Osprey 2  
Modification to Hull  
addition of 4" forward of step  
Dwg #2A

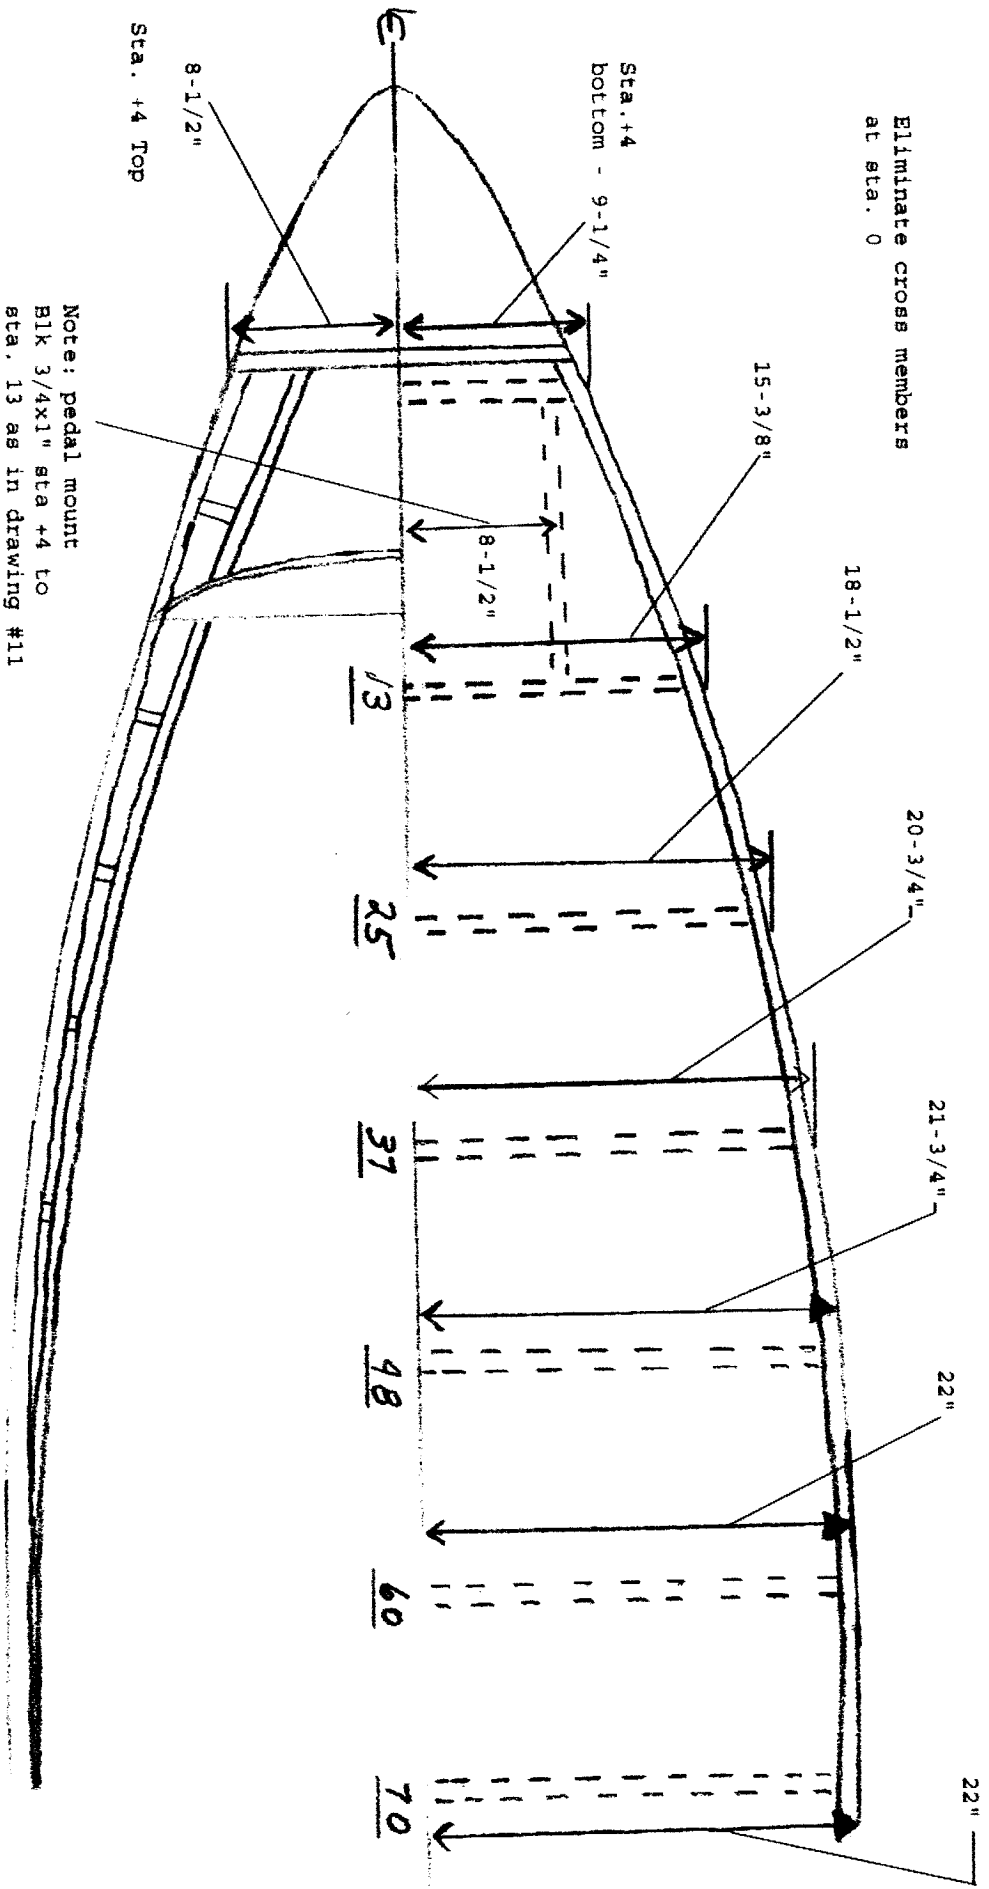
Note: Cross member sta. widths may be adjusted slightly to a fair curve (sta. 70 & +4 should be + or - 1/8")

All hardware is bolted in same position or rudder pedals and brakes can be moved forward 4" for additional leg room.

Aft of sta. 60 cross widths are same as original plans
